Application of 247 Westwood Avenue Corporation  
Use Variance, Bulk Variances, Parking Variance, and  
Amended Major and/or Minor Site Plan Approval  
Westwood Board of Adjustment  
Monday, June 29, 2020

**AMENDMENT TO  
APPLICATION FOR  
LIMITED BREWERY**

**Five Dimes Brewery**  
247 Westwood Avenue  
Westwood, New Jersey  
Block 811, Lot 9

# A-102.00

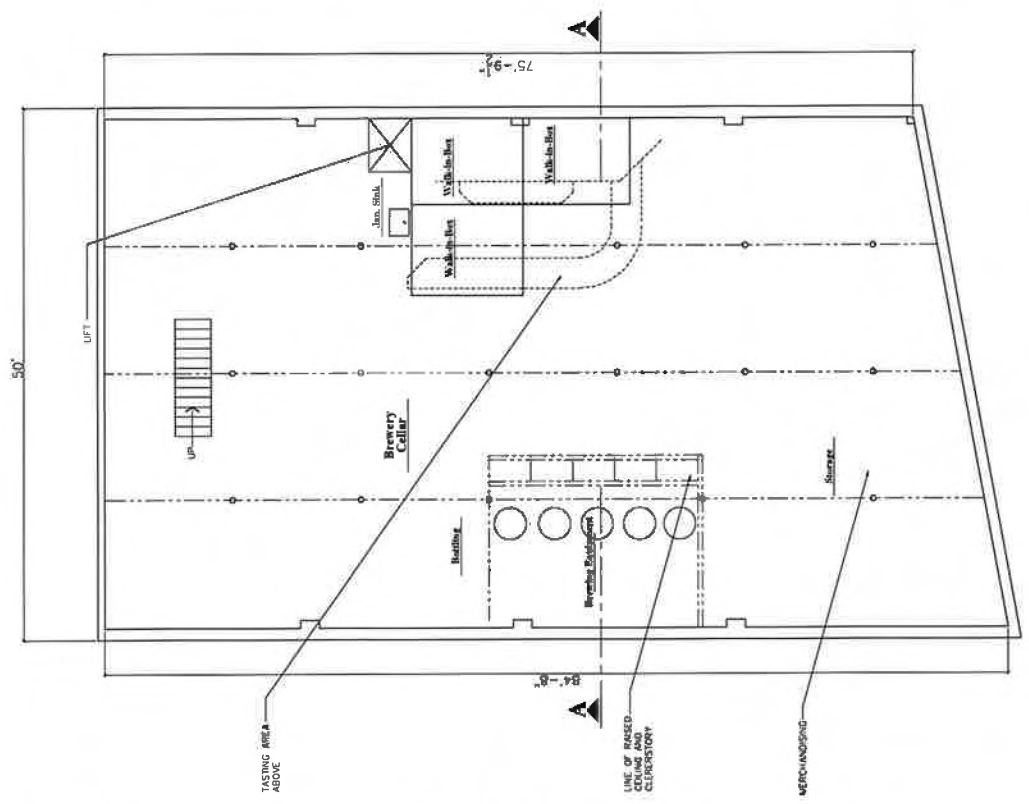
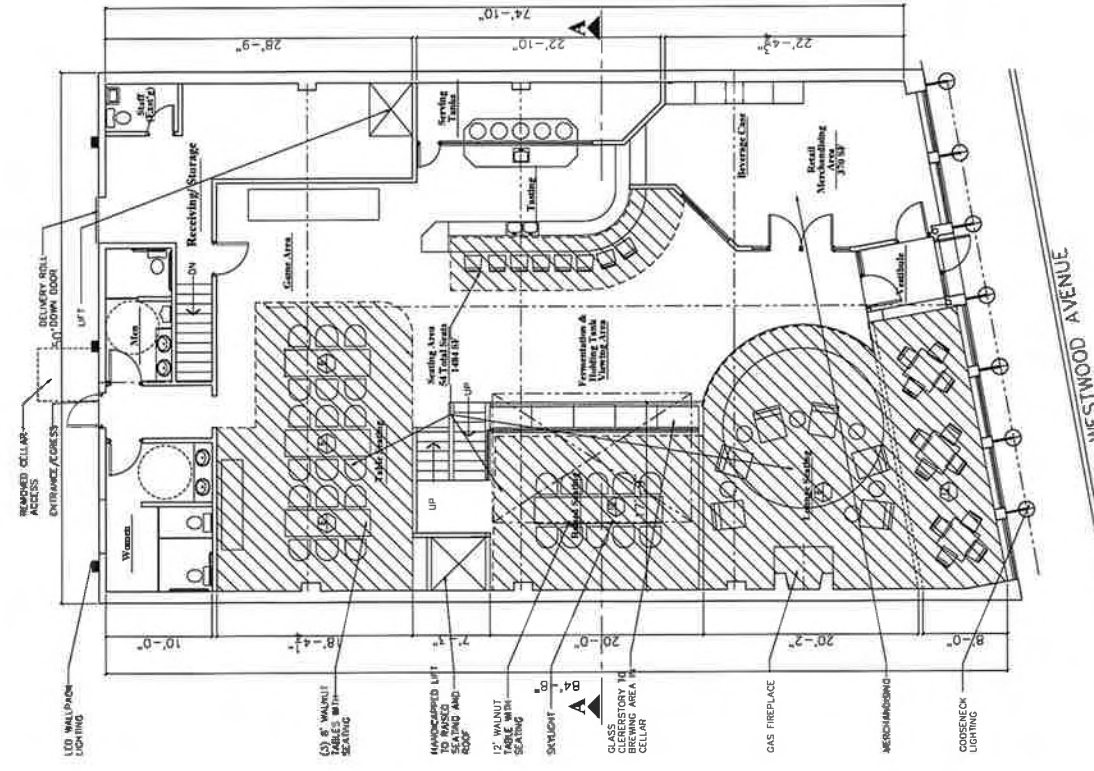
2. **Total seating reduced to 68 seats:** The original plan called for a total of 132 seats in the limited brewery. In the amended plan, a total of only 68 seats is proposed.

3. **Reduction of seats on roof to 14 seats:** The application still seeks approval for use of the roof, but with less seats—and on a seasonal basis. The original plan called for 47 seats on the roof, with the concomitant parking demand discussed below. The amount of seating in the amended plan greatly reduces the seats to only 14 seats on the roof. Additionally, there are significant enhancements to the landscaping plan on the roof. (The roof also includes skylights to the brewery below, not present on the original plan.) There is an adjacent tasting area with 2

5. **Increase in proposed on-site parking spaces to 12: dumpster:** The original plans called for the creation of a dumpster at the southwest corner in the rear of the building, which also required the removal of one existing parking space. That is eliminated on the revised plans; the existing dumpster will continue to be used. A total of 12 on-site parking spaces are proposed, including the existing parking spaces plus one new van-accessible handicapped space.

6. **Roof top has been modified by tasting area:** The original plan also called for a bar on the roof with 18 seats. That has been eliminated in favor of a general seating area where 12 seats are located and a tasting area with two seats (for a total of 14 roof top seats, as previously noted).

7. Retail area: With the elimination of the restaurant use, the larger area for the limited brewery on the first floor allows for small retail sales area which includes a beverage case for retail sales, not previously proposed.

8. Other changes: The seating has also been reorganized and modified from the original layout as shown. Additionally, a walk-in box, shown on the original plans, is no longer proposed on the revised plans. A new delivery entrance will also be created at the rear of the property. The cellar hatch, which was proposed to be located at the rear of the building, is no longer proposed.
